MIL-C-17588E(SH)
 AMENDMENT 5
24 June 1993
 SUPERSEDING
 AMENDMENT 4
 5 July 1988

MILITARY SPECIFICATION

CIRCUIT BREAKERS (AUTOMATIC - ALB-1) AND SWITCH, TOGGLE
 (CIRCUIT BREAKER, NON-AUTOMATIC - NLB-1) AIR, INSULATED HOUSING,
 125 VOLTS AND BELOW, A.C. AND D.C., (NAVAL SHIPBOARD USE)

1C. Outline dimensions for mounting bases for two circuit breakers.
(Type MB-TP)

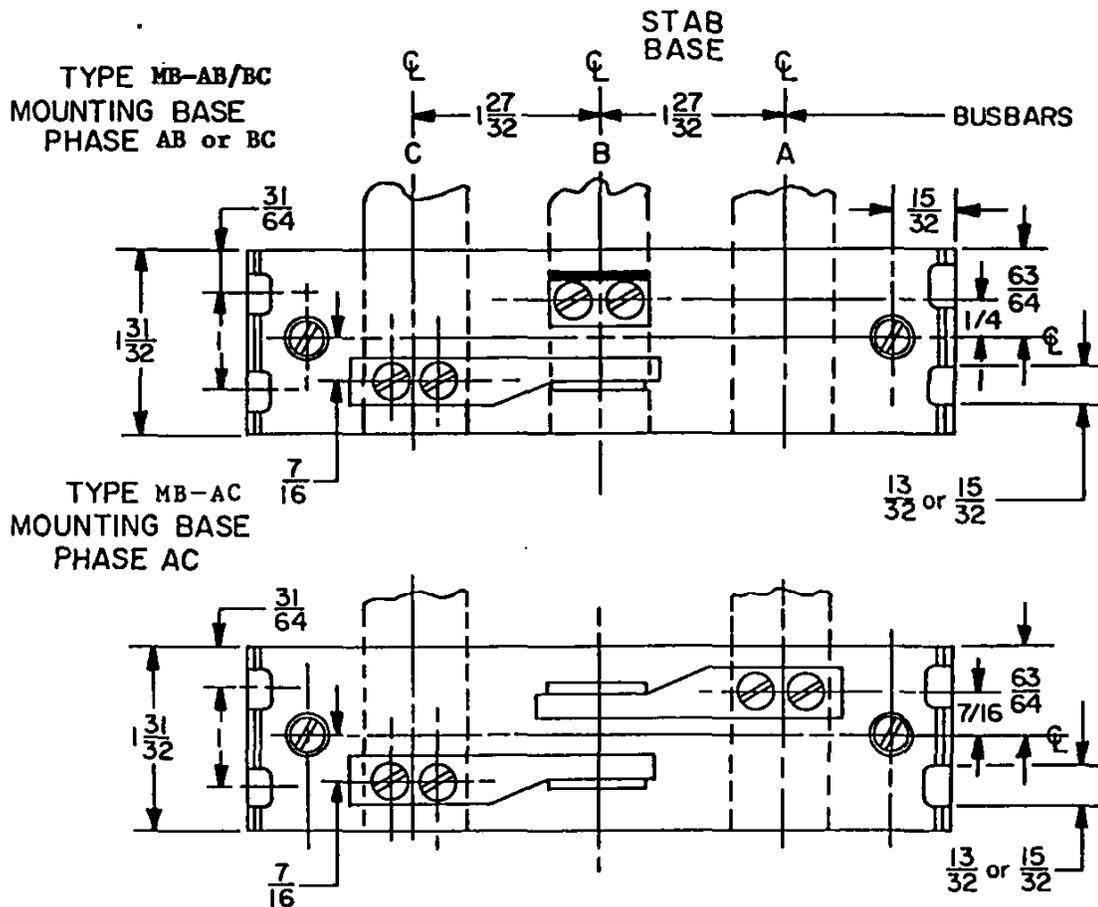
- * Figure 1: Delete and substituted attached figure 1C.

1D. Outline dimensions for mounting bases for circuit breakers

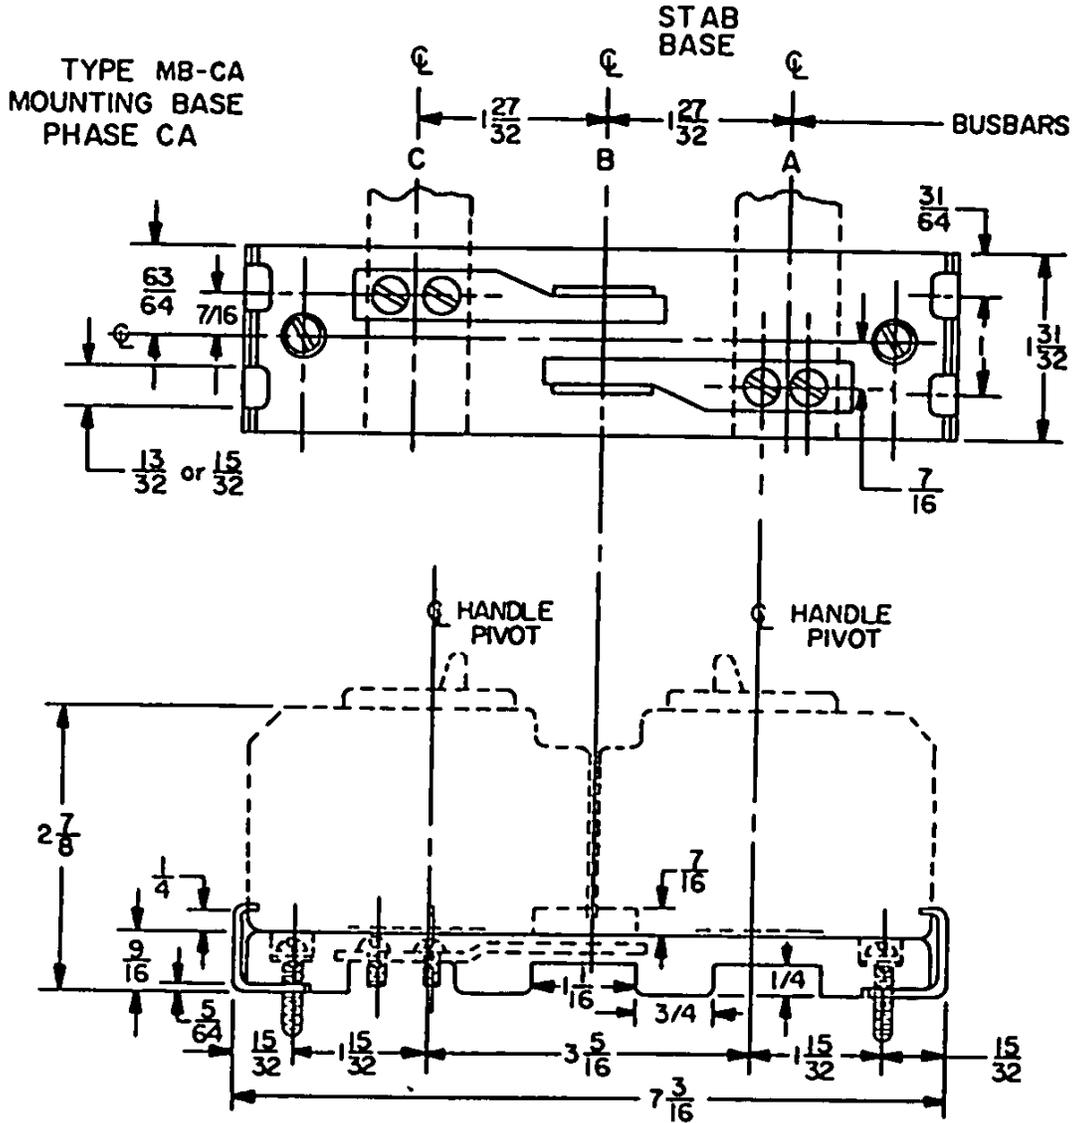
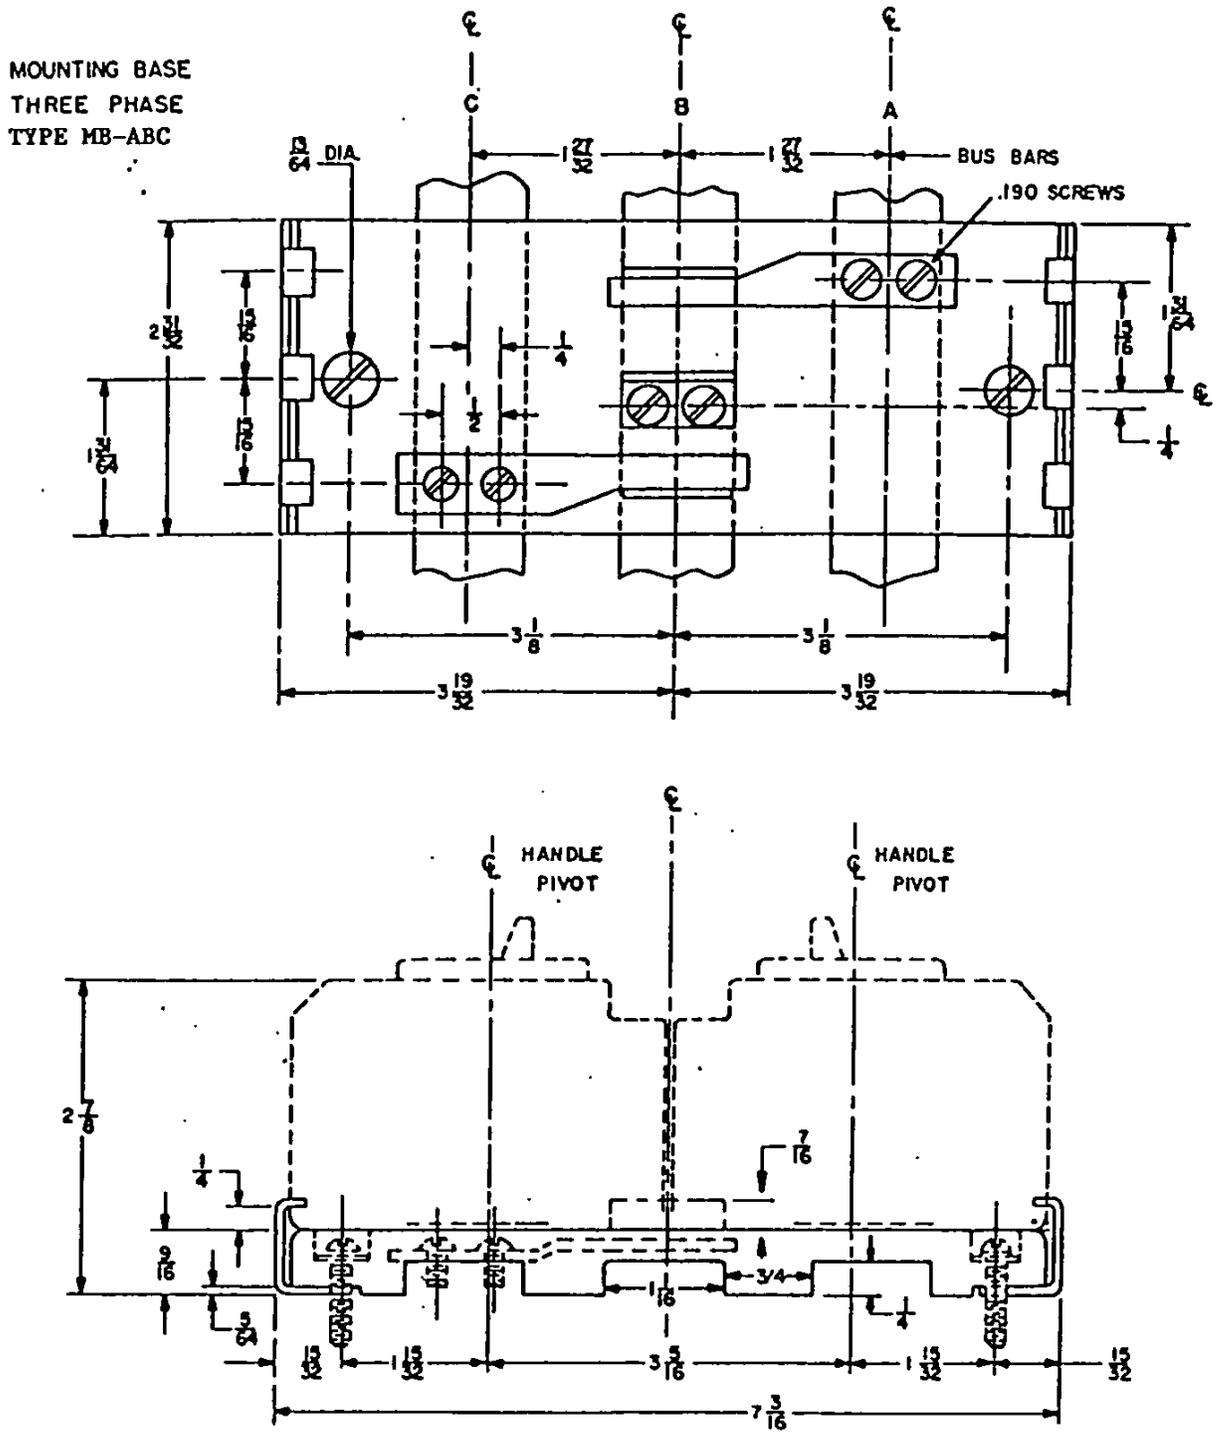
- * Figure 1: Delete and substitute attached figure 1D (pages 10, 11 and 12).
